STAFF REPORT
Mueller Subdivision

Application No.: 217-25-000150-PLNG

Request: The property owner is requesting development plan approval for a 7-lot subdivision on property zoned Recreation Residential Zone, RR(M)-5 (5-acre minimum lot size). The subject property is approximately 58.72 acres. The property is currently vacant. The Applicant proposes to develop the subdivision in one phase.

Attachment A – Tentative Plan

TENTATIVE PLAN FOR THE PROPOSED MUELLER SUBDIVISION, BEING PARCEL 1 OF PARTITION PLAT 2024-06, LOCATED IN SECTION 20, TOWNSHIP 16 SOUTH, RANGE 17 EAST, W.M., CROOK COUNTY, OREGON.

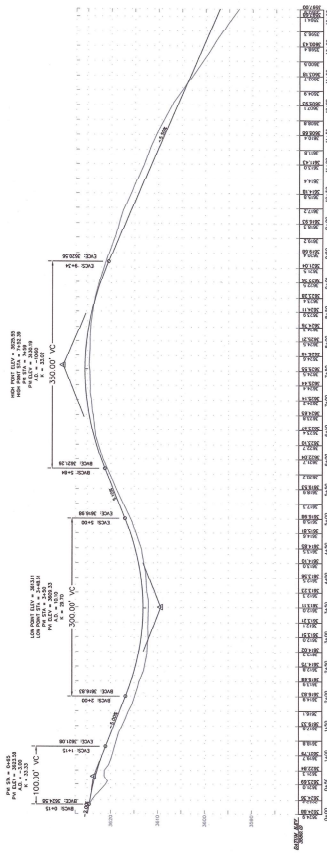
Proposed Finding: As proposed, there is one road with access from SW Juniper Canyon Rd., with a cul-de-sac at the eastern end. It is laid out independent of road north of the property that accesses multiple properties to the east. It is also independent of the subdivision to the south of the property.

As proposed, the road does not conform with connectivity to and within existing development. The Planning Commission will need to consider if a connection, which could be through an easement would be beneficial for the county or if the current proposal is in the public interest.

Proposed Finding: The tentative plan for shows a public road with a 60 foot right of way for access to all proposed lots. The final plat shall reflect the road and right of way, as a private road, along with any reservations or restrictions relating to such road.

Proposed Finding: The plan has a scale of one inch to 200 feet. The tentative plan is of an appropriate scale to depict the required information.

Proposed Finding: The tentative plat shows the proposed street width. There are no special district boundaries, and the Applicant/Agent will place monuments when surveying for the final plat. There are no existing permitted structures, irrigation canals and ditches, pipelines, waterways, railroads, or any natural features such as rock outcroppings, marshes, wooded areas, and natural hazards to depict. The property does not have any mapped floodways or waterways. As depicted, there are no existing sewer lines, water mains, culverts, and other underground and overhead utilities within and adjacent to the proposed subdivision together with pipe sizes, grades and locations. Easements are depicted on the tentative plat.

A condition of approval is included that requires the Applicant will provide cross sections and plans for the proposed subdivision road for the Road Superintendent review.

14. The Applicant will provide road cross sections to the Road Superintendent and Planning Department. Roads will be designed to meet the standards for 21-99 PADT (Passenger average daily trips).
